Published date	13/02/2019
Document number	SUPAIR_2019/02/002
Page number	1 / 2

Safety info

SUBJECT : ACCESS BACK and AIRBAG (2007 et 2008)

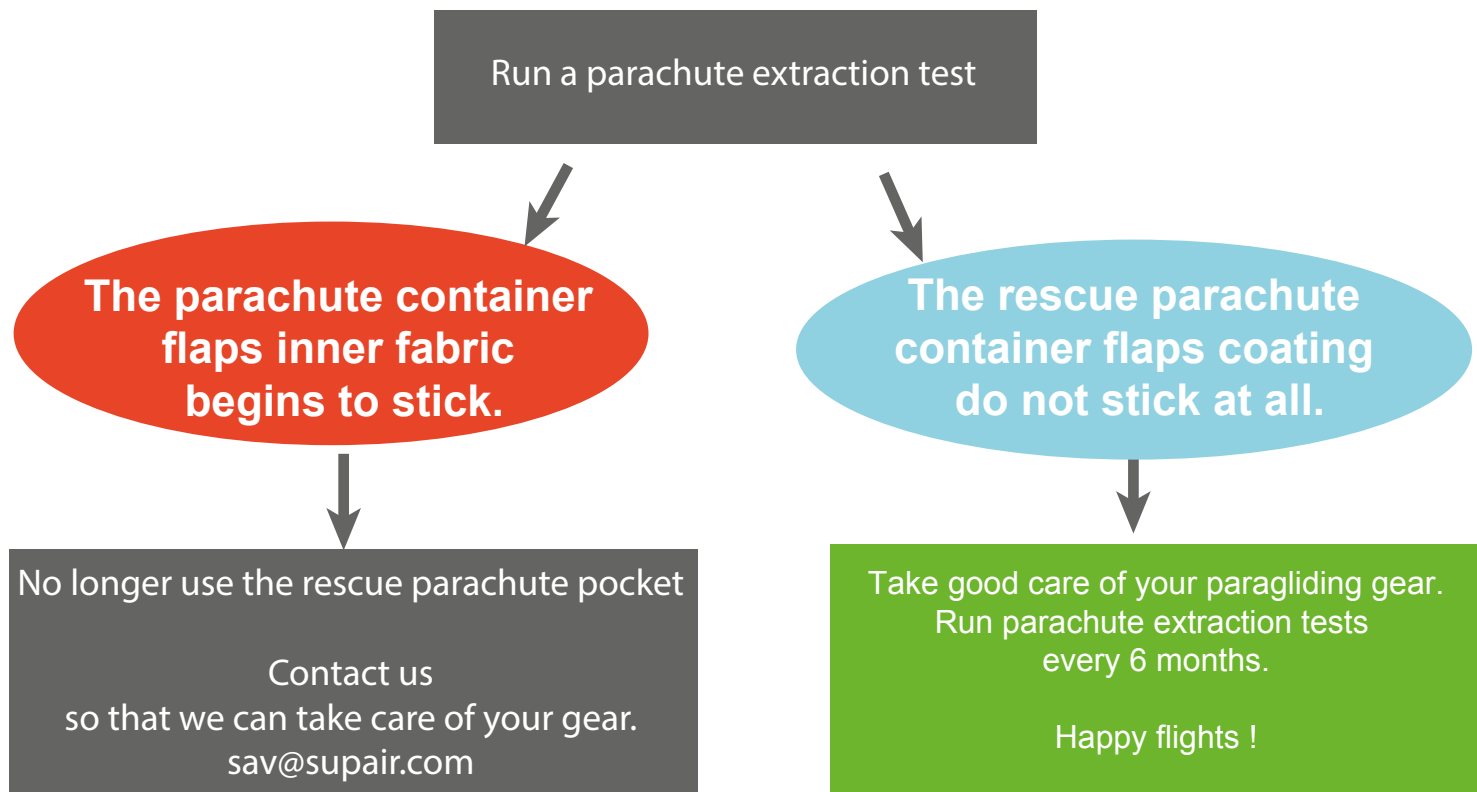
The coating on the rescue parachute container flaps might become sticky.

The coating of the black Cordura might deteriorate overtime and become sticky. It is possible that the degraded rescue parachute container flaps affect the parachute extraction, making it harder or even impossible.

During their yearly parachute extraction test, several pilots noticed that the rescue parachute container flaps had become sticky.

(Fabric defect as regards to the stability of the coating overtime)

DELAIS : **The inspection must be done immediately**
